## **22\_02066\_FUL-RESPONSE\_TO\_OBJECTIONS\_FROM\_VARIOUS\_PARTIES-6038871**

**GM Comments 30/09/2022 rev1**

- 1) This report has been prepared to make some key comments on the following planning submissions in relation to ecology:

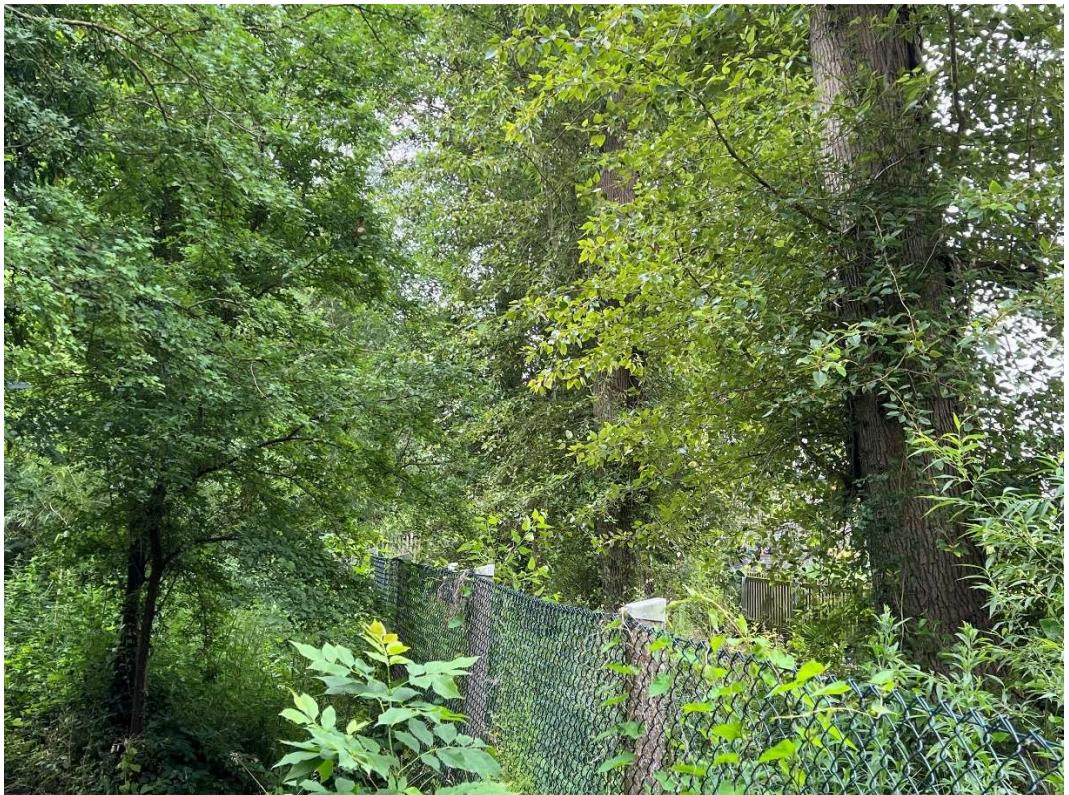
The key point here is that Turley have not considered the trees in the context of their providing a habitat along which bat activity has been noted.

As Bioscan have pointed out in previous reports, the tree line is assessed to be ecologically continuous with the nature reserve in terms of usage by bats (see photos below). As such, **the removal of these trees would be expected to have an impact on bat activity (including on the rare bat species barbastelle)**, and must be considered in this context.
